# Access Compliance Report

## Public Rights-of-Way

Intersection ID: 15069	Main Street: BRUNSWICK_AV	Cross Street: MEDICAL_CENTER_DR	Location: NE
ADA ID: 7D5F664BB9E0	Ramp Type: PerpDiag	Initial Pass/Fail: Fail	Overall Compliance: No
			Severity Score: 13.75

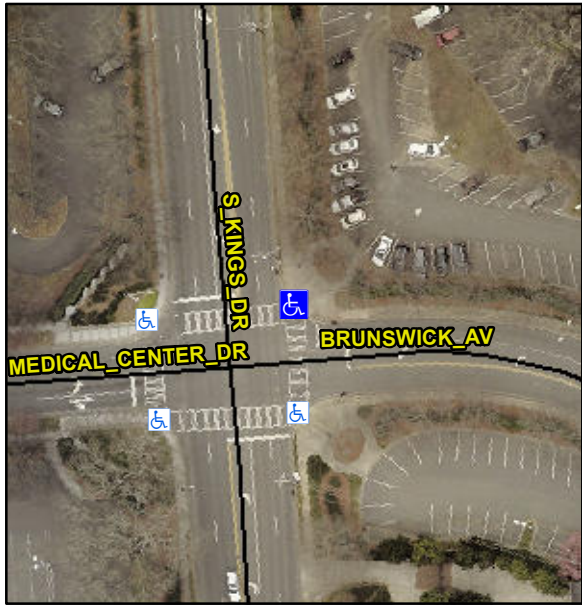
Codes/Mitigation Info/Possible Solution			Field Measurements/Component Compliance					
	Possible Solutions:		Compliance	Description	Data	Compliance	Description	Data
	Remove & Replace Curb Ramp With Two New Directional Ramps or Equivalent.		N/A	Ramp Length (in)	60.0	No	Ramp Slope (%)	9.5
			Yes	Ramp Width (in)	48.0	No	Ramp XSlope (%)	3.7
			N/A	Flare Type LT	N/A	N/A	Flare Type RT	N/A
			N/A	Flare Slope LT (%)	N/A	N/A	Flare Slope RT (%)	N/A
			N/A	Flare Traversable LT?	N/A	N/A	Flare Traversable RT?	N/A
			N/A	Landing Length (in)	N/A	N/A	DWS Provided?	N/A
			N/A	Landing Width (in)	N/A	N/A	DWS Contrast?	N/A
			N/A	Landing Slope (%)	N/A	N/A	DWS Length (in)	N/A
			N/A	Landing X Slope (%)	N/A	N/A	DWS Full Width?	N/A
Surveyor Notes:		N/A	N/A	Landing Curb? (Y/N)	N/A	N/A	DWS Offset (in)	N/A
PROW/ADA:		Not Found, R304.2.2, R304.5.3	N/A	Shared Landing?	N/A			
			N/A	Gutter Ponding?	N/A	N/A	Gutter Slope (%)	N/A
			N/A	Gutter Lip Ht (in)	N/A	N/A	Gutter X Slope (%)	N/A
